1. REPORT DATE (DD-MM-YYYY) 18 Jun 2012		2. REPORT TYPE Consultative Letter		3. DATES COVERED (From – To) Oct 2011 – May 2012	
4. TITLE AND SUBTITLE Review of Hangar Door Design of Mountain Home AFB (MHAFB) Refurbished Non-Destructive Inspection (NDI) Facility				5a. CONTRACT NUMBER	
				5b. GRANT NUMBER	
				5c. PROGRAM ELEMENT NUMBER

SUBJECT: Consultative Letter AFRL-SA-WP-CL-2012-0056, Review of Hangar Door Design of Mountain Home AFB (MHAFFB) Refurbished Non-Destructive Inspection (NDI) Facility

SUBJECT: Radiation Scatter Survey at Bldg 1335 Non-Destructive Inspection,
WIC: 0136-FAND-461A

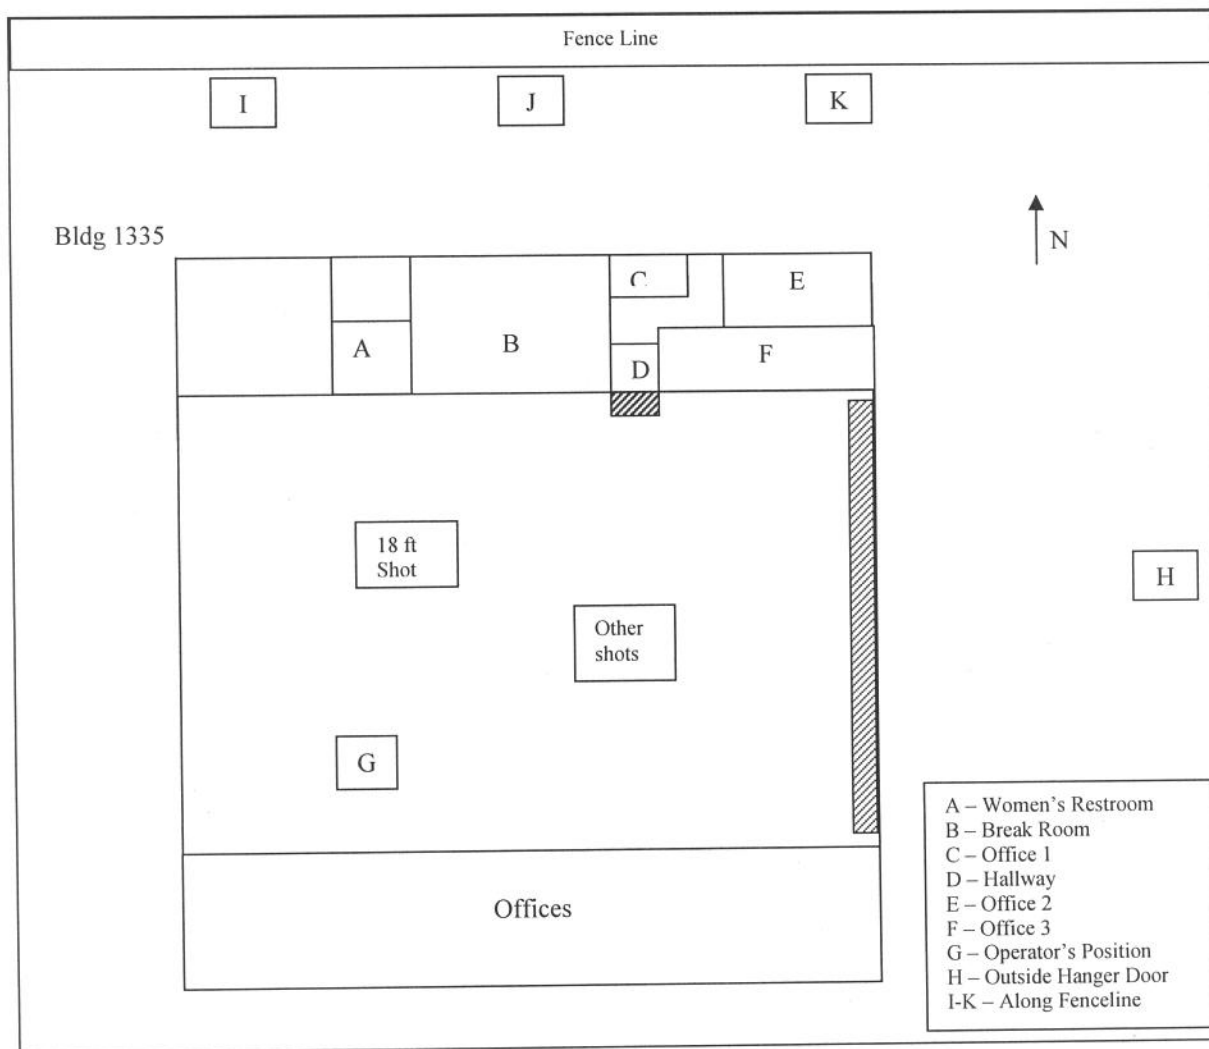
max readings reported below from 4 shots (aiming down, up, 45 degrees and 18ft stabilizer shot to side wall of Bldg 1335)

Location	Radiation Level (mR/hr)				
	Straight Down	Straight Up	45 degrees	18 ft Stabilizer Shot Facing North	18 ft Stabilizer Shot Facing South
A	0.036	0.20	0.50	No Data	No Data
B	0.058	0.24	0.90	> 2.3	No Data
C	0.060	0.10	0.38	No Data	No Data
D	0.070	0.25	1.5	No Data	No Data
E	No Data	0.10	0.36	No Data	No Data
F	0.070	0.25	1.2	> 2.0	No Data
G	2.10	1.3	1.6	No Data	15
H	Background	0.42	0.92	No Data	No Data
I	No Data	No Data	No Data	0.61	No Data
J	No Data	No Data	No Data	0.9	No Data
K	No Data	No Data	No Data	0.56	No Data
